FORD:
2013 Fusion

ISSUE

TSB 13-5-24 (Continued)

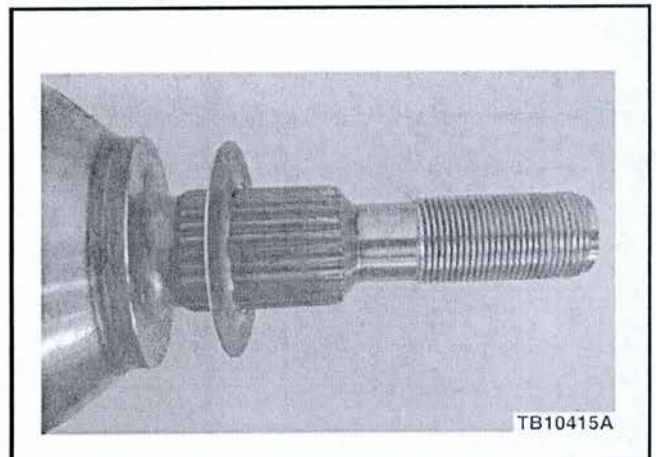
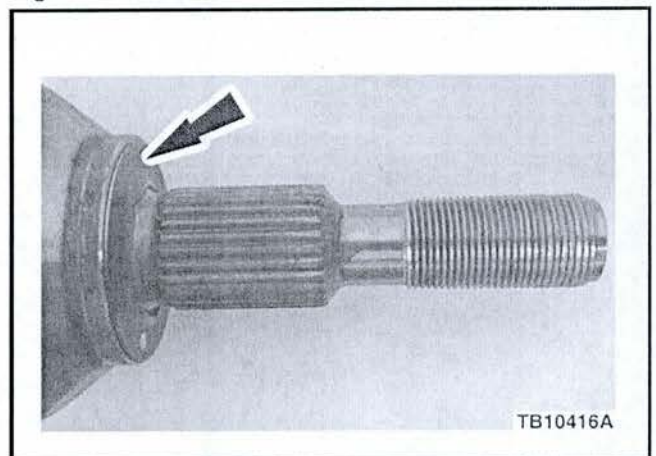
3. Install one (1) thrust washer over the halfshaft splines until the metal ring is flat against the wheel bearing mating surface. The taper should face outward toward the hub/splines. (Figures 2 and 3)
